**CITY OF FRANKLIN****REPORT TO THE PLAN COMMISSION**

Meeting of November 3, 2016

**Site Plan**

<b>Project Name:</b>	Anderson Family Dental Site Plan
<b>Project Location:</b>	7215 West Rawson Avenue
<b>Property Owner:</b>	BMO REO-WI LAND LLC
<b>Applicant:</b>	Charles Anderson, Anderson Family Dental
<b>Agent:</b>	Shaun Sullivan, Design2Construct
<b>Current Zoning:</b>	B-3 Community Business District
<b>2025 Comprehensive Plan:</b>	Commercial
<b>Use of Surrounding Properties:</b>	Commercial (Root River Center) to the north, vacant R-6 District zoned property to the south, multi-family (zoned PDD No. 17) to the east and vacant commercial land to the west
<b>Applicant's Action Requested:</b>	Approval of the Site Plan Application for Anderson Family Dental

**WETLAND MITIGATION AREA**

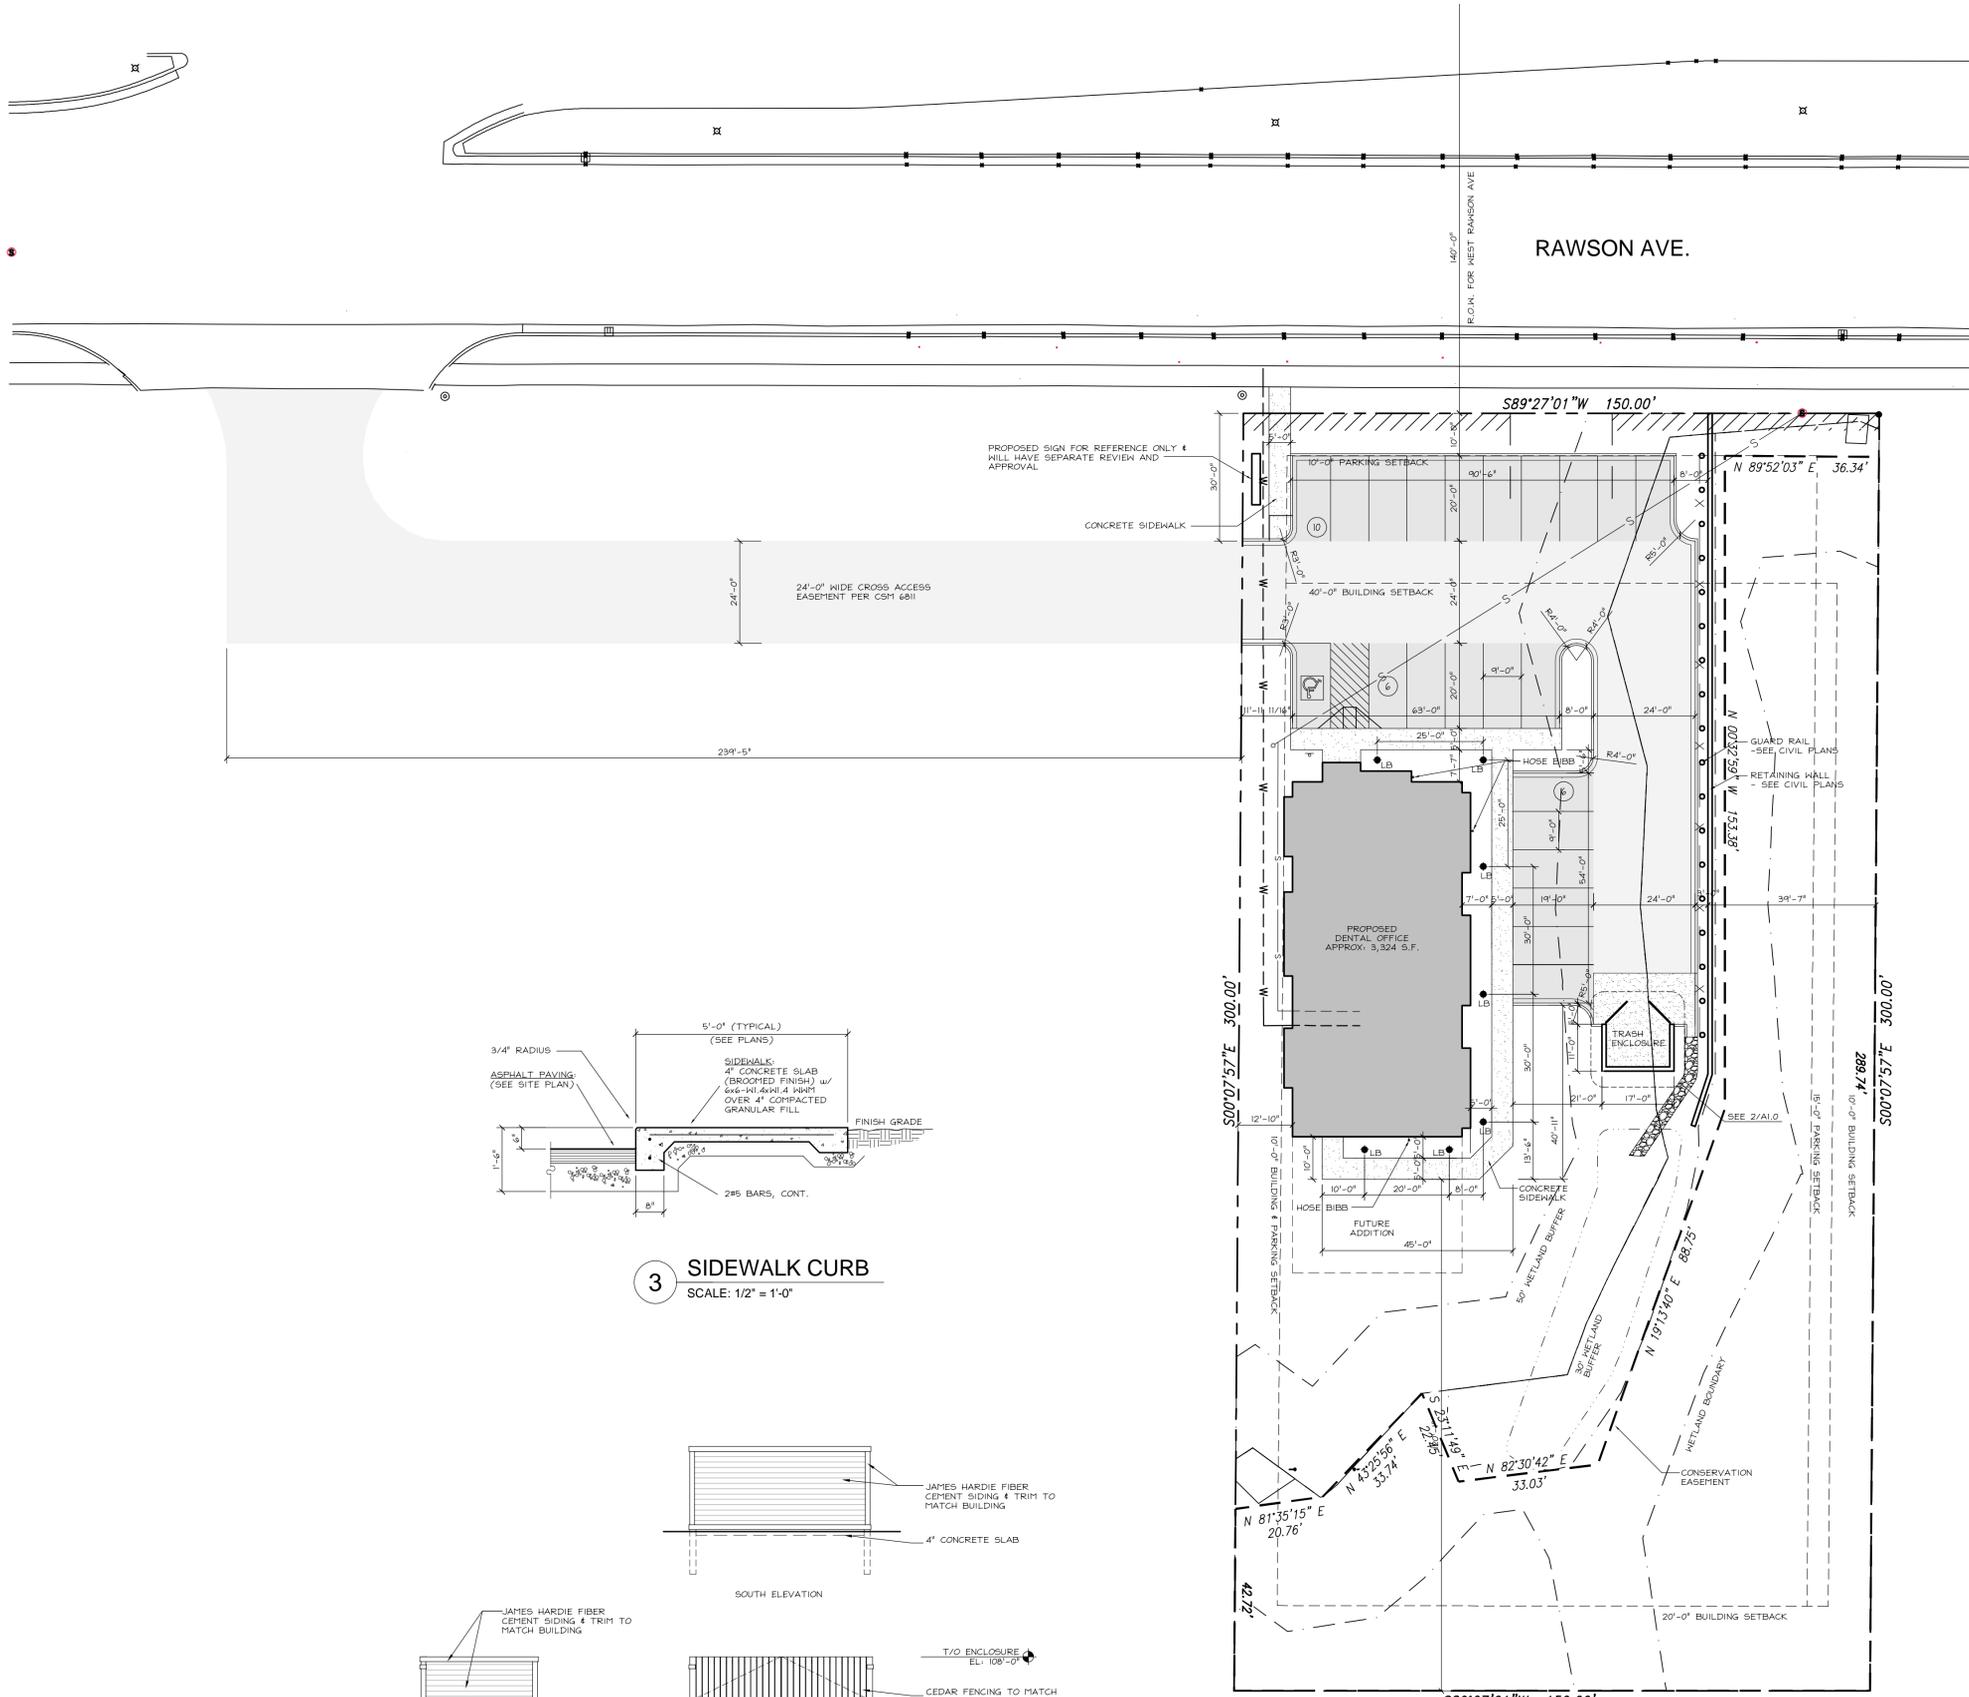
With twenty-two (22) parking spaces provided, five plantings of each type (Canopy/Shade Tree, Evergreens, Decorative Trees and Shrubs) are required per Table 15-5.0302 of the UDO. However, the property to the south is zoned R-6 Suburban Single-Family Residence District. In addition, the properties to the east contain a multi-family use, zoned PDD No. 17. Section 15-5.0302C. of the UDO states that when a development abuts a residential zoning or use the minimum quantity of plantings required in Table 15-5.0302 increases by twenty (20) percent, the emphasis of plantings shall be on placing the increased amount within the bufferyard and that evergreens and arborvitae are required within the buffer yard with a minimum planting height of six (6) feet. The 20% increase in plantings results in a minimum of six plantings of each type required.

The applicant is proposing seven Canopy/Shade trees, eight Evergreens, five Decorative trees and thirty-one Shrubs, which exceeds the requirements of Table 15-5.0302 of the UDO. Note that although five, not six decorative trees have been provided, the UDO allows, where appropriate, the replacement of decorative trees with shade trees.

REQUIRED: 10,792 SF. PER NRPP

SHOWN: 10,860 SF.

**1** SITE PLAN  
SCALE: 1" = 20'-0"

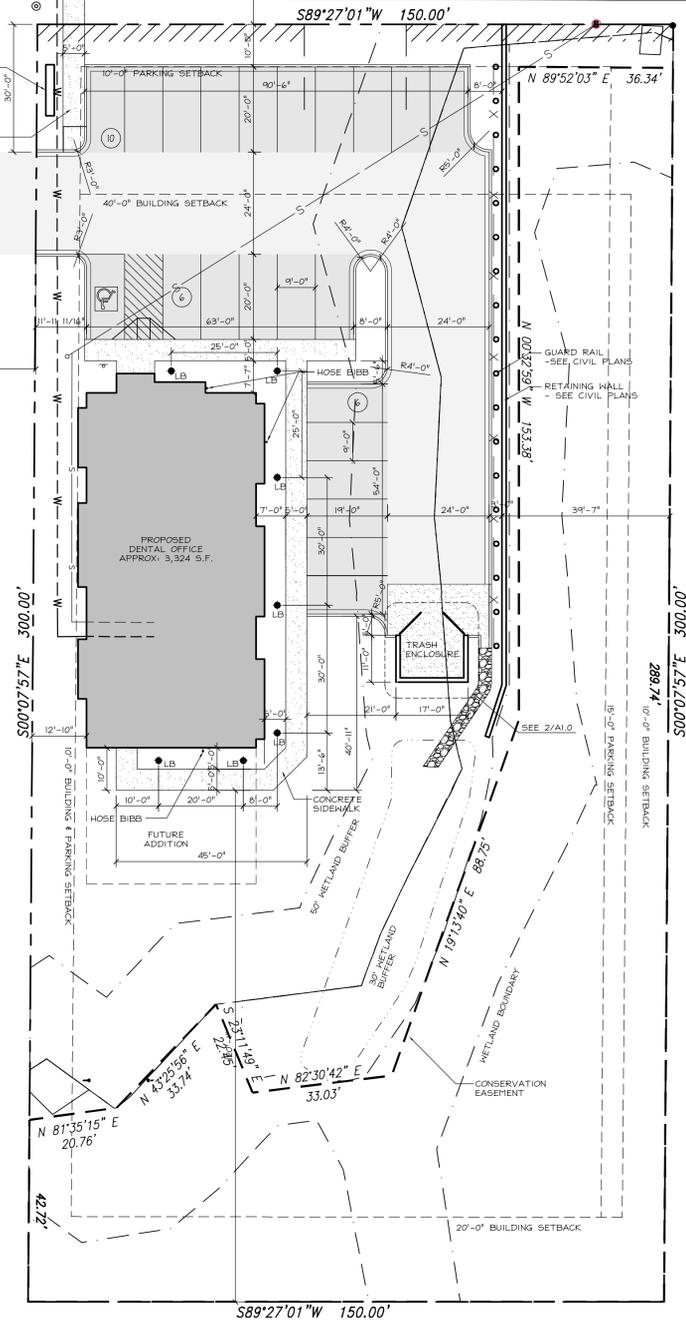
Note that some of the Site Data on the Site Plan, Sheet A1.0, is not correct. For example, the future addition is 1,280 square feet, not 510 square feet, the proposed building is 3,324 square feet, not 6,651 square feet and the parking provided is 22 parking spaces, not 33. Staff recommends that the applicant shall submit a revised Site Plan, Sheet A1.0, with corrected Site Data information to the Department of City Development, prior to issuance of a Building Permit.
